ARKANSAS NUCLEAR ONE, UNIT NO.1

Amendment No. 76
License No. DPR-51

ARKANSAS NUCLEAR ONE, UNIT NO.2

Amendment No. 43
License No. NPF-5

Figure 3.8.1

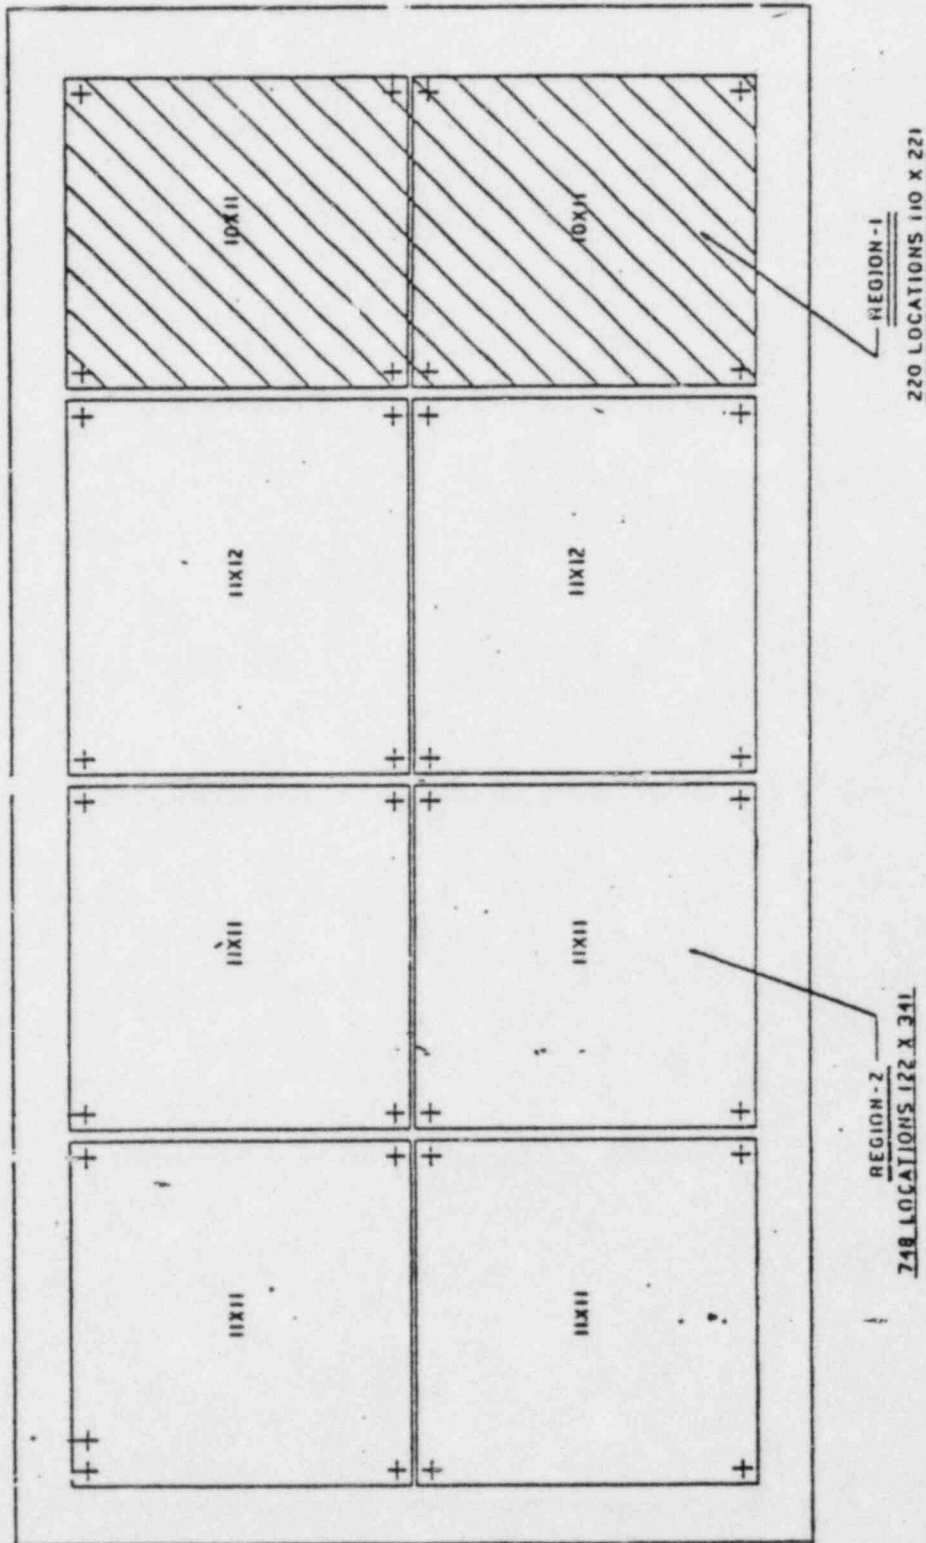
- 3.8.15 The spent fuel shipping cask shall not be carried by the Auxiliary Building crane pending the evaluation of the spent fuel cask drop accident and the crane design by AP&L and NRC review and approval. The provisions of Specifications 3.0.3 and 3.0.4 are not applicable.
- 3.8.16 Storage in the spent fuel pool shall be restricted to fuel assemblies having initial enrichment less than or equal to 4.1 w/o U-235. The provisions of Specifications 3.0.3 and 3.0.4 are not applicable.
- 3.8.17 Storage in Region 2 (as shown on Figure 3.8.1) of the spent fuel pool shall be further restricted by burnup and enrichment limits specified in Figure 3.8.2. The provisions of Specifications 3.0.3 and 3.0.4 are not applicable.
- 3.8.18 The boron concentration in the spent fuel pool shall be maintained (at all times) at greater than 1600 parts per million.

Specification 3.8.14 will assure that damage to fuel in the spent fuel pool will not be caused by dropping heavy objects onto the fuel. Administrative controls will prohibit the storage of fuel in locations adjoining the walls at the north and south ends of the pool, in the vicinity of cask storage area and fuel tilt pool access gates, until the review specified in 3.8.15 is completed.

FIGURE 3.8.2

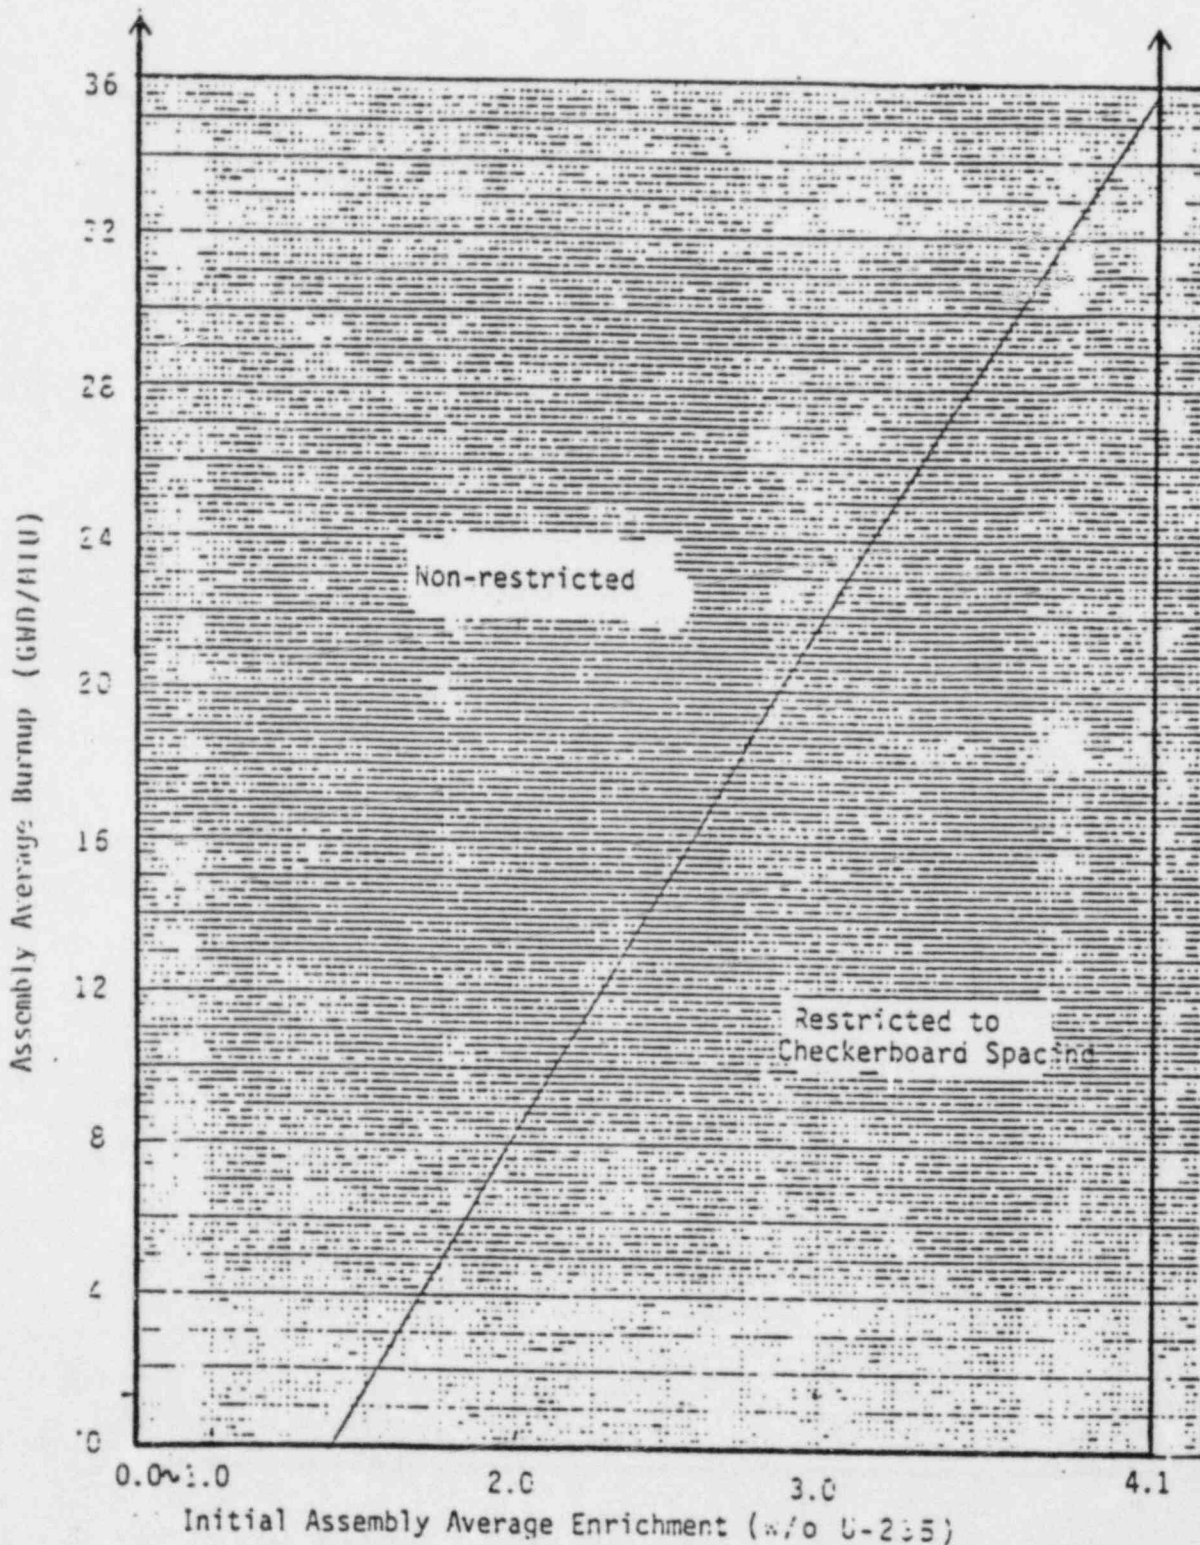
Specifications 3.8.16 and 3.8.17 assure fuel enrichment and fuel burnup limits assumed in the spent fuel safety analyses will not be exceeded.

Figure 3.9.1

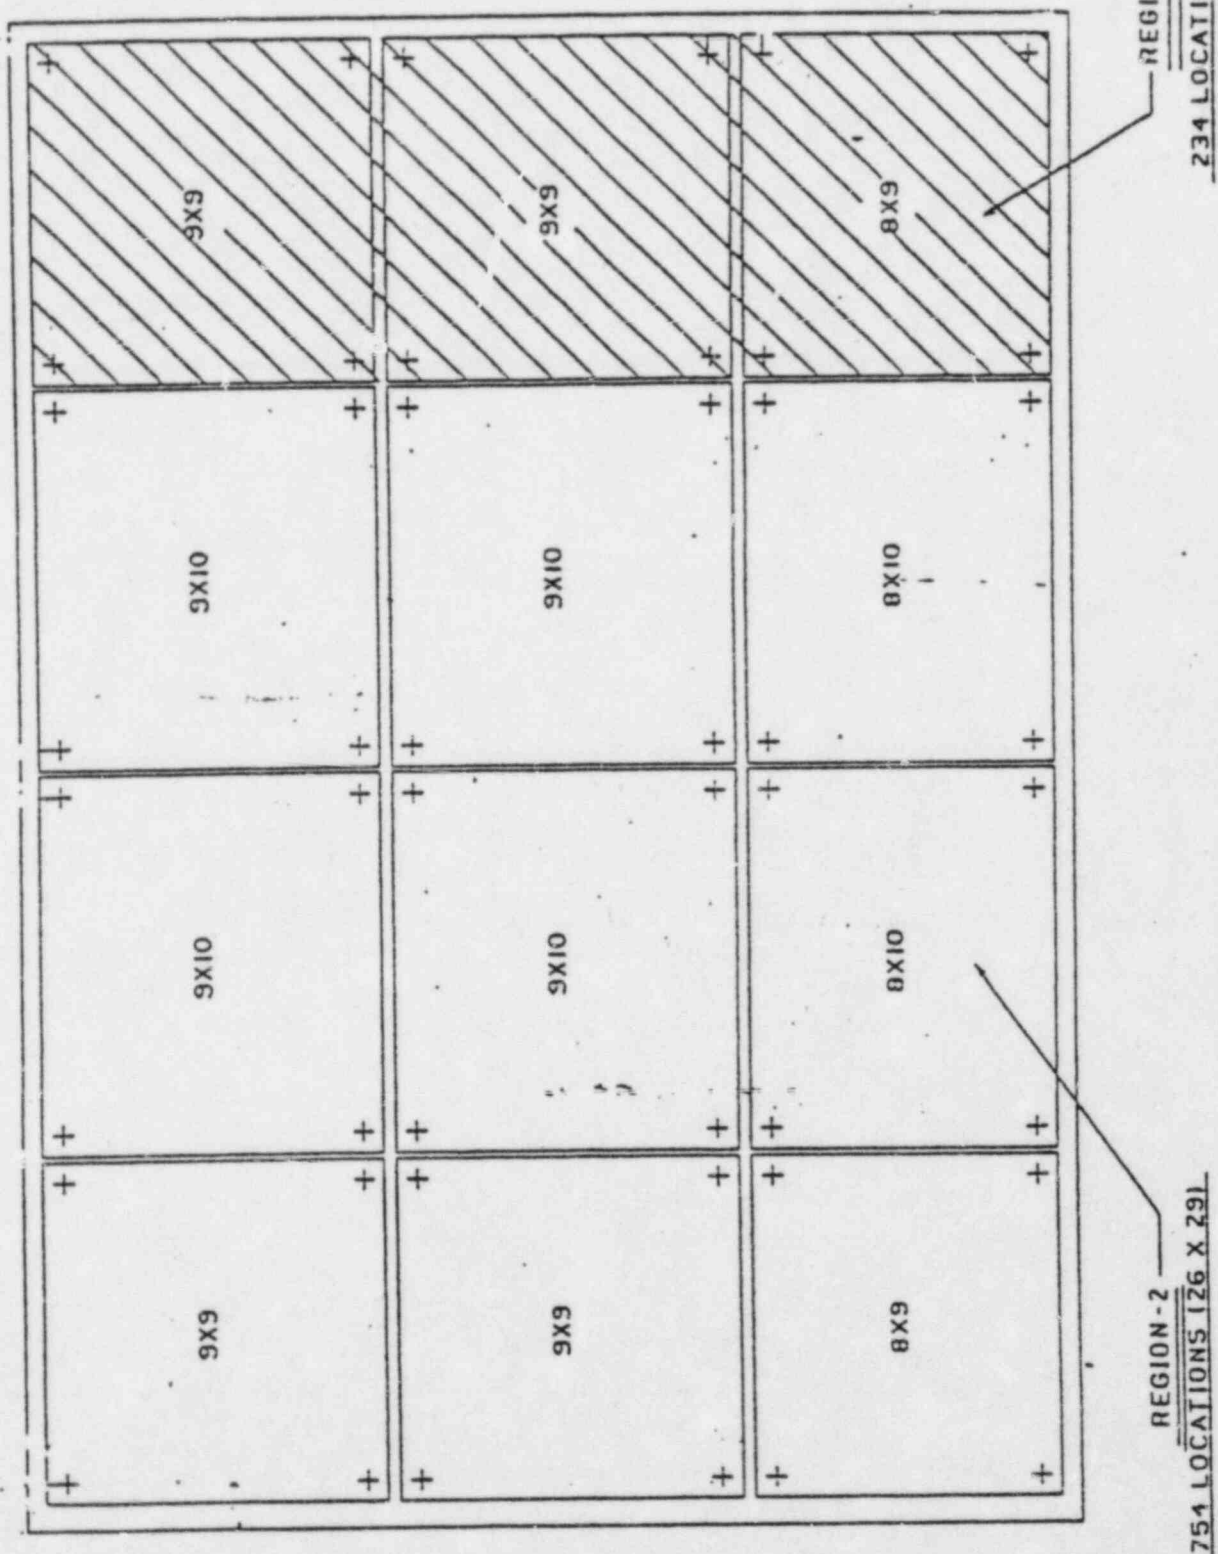
3.9.12.b Storage in Region 2 (as shown on Figure 3.9.1) of the spent fuel pool shall be further restricted by burnup and enrichment limits specified in Figure 3.9.2. In the event a checkerboard storage configuration is deemed necessary for a portion of Region 2, vacant spaces adjacent to the faces of any fuel assembly which does not meet the Region 2 burnup criteria (Non-Restricted) shall be physically blocked before any such fuel assembly may be placed in Region 2. This will prevent inadvertent fuel assembly insertion into two adjacent storage locations. The provisions of Specification 3.0.3 are not applicable.

FIGURE 3.9.2

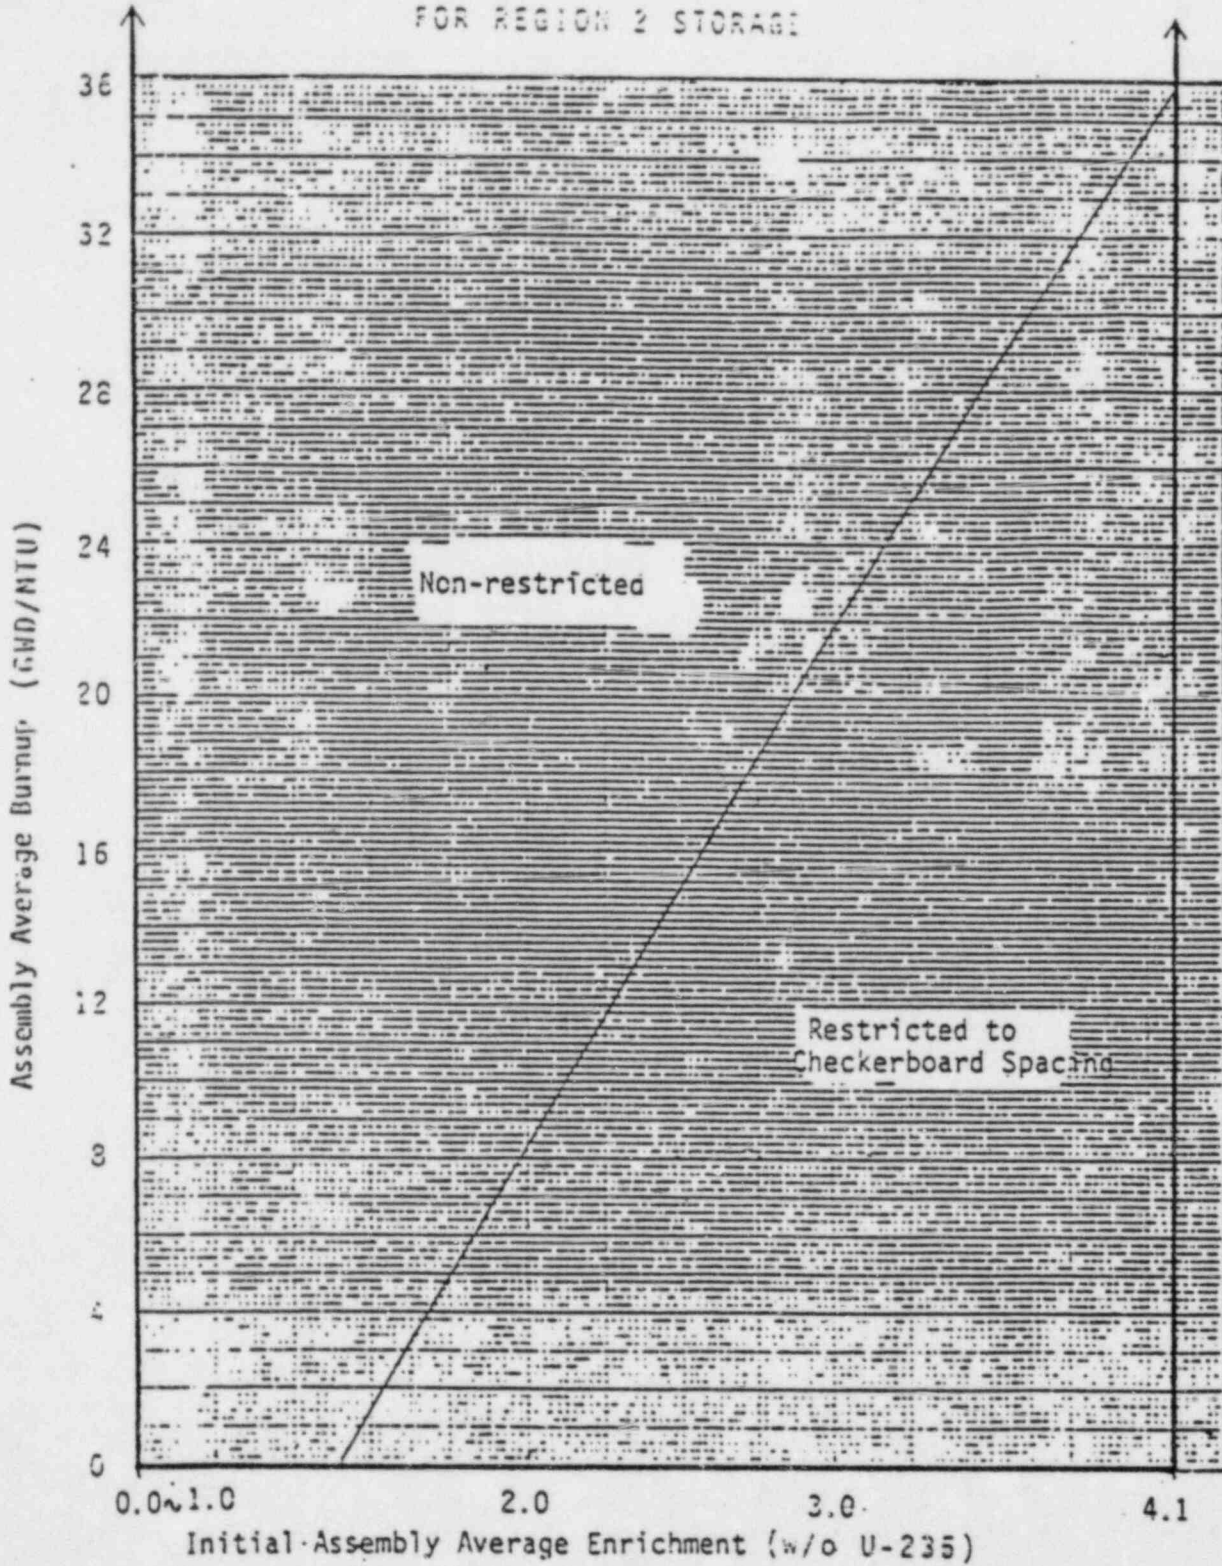
4.9.12.b Verify all fuel assemblies to be placed in Region 2 of the spent fuel pool are within the enrichment and burnup limits of Figure 3.9.2 by checking the assemblies design and burnup documentation.

Region 2 of the spent fuel storage racks is designed to assure fuel assemblies within the burnup and initial enrichment limits of Figure 3.9.2 will be maintained in a subcritical array with $K_{eff} \leq 0.95$ in unborated water. These conditions have been verified by criticality analyses.
